SB Number:	SB 2H0-018	Creation Date: 05/02/2009
Subject:	Abnormal noise from paper conveying section 2	
Model:	KM-2540/3040/2560/3060

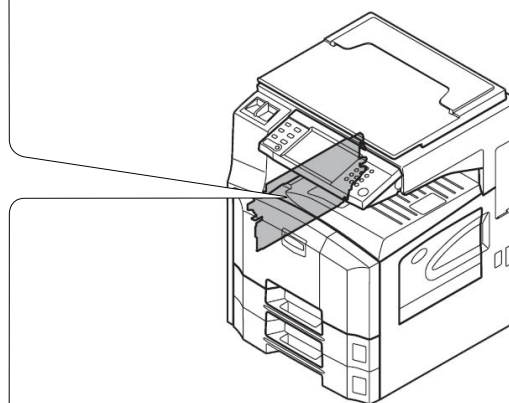
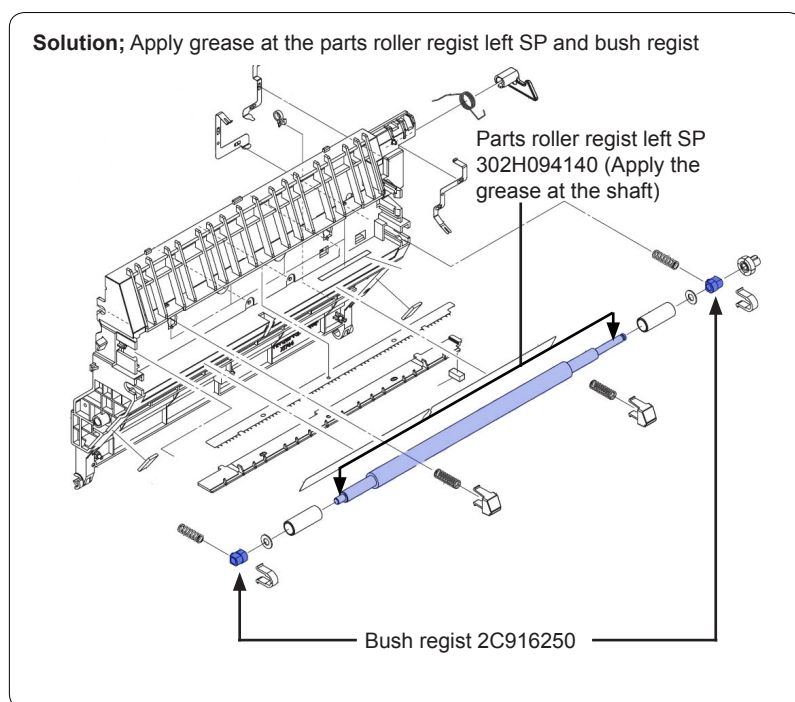
Phenomenon	Abnormal noise may occur at paper conveying section 2, when feeding the second sheet of paper from the paper cassette or bypass tray.
-------------------	---

Solution	Apply grease molykote EM-50LP 50G (7BG010009H) at parts roller regist left SP (302H094140) and Bush regist (2C916260).
-----------------	--

Classification	<input type="checkbox"/> Entire stock rework	<input type="checkbox"/> In-field modification at next visit	<input checked="" type="checkbox"/> In-field modification by case	<input type="checkbox"/> No modification necessary
Field measure	When the above mentioned phenomenon occurs, please apply grease molykote EM-50LP 50G (7BG010009H) at parts roller regist left SP (302H094140) and Bush regist (2C916260)
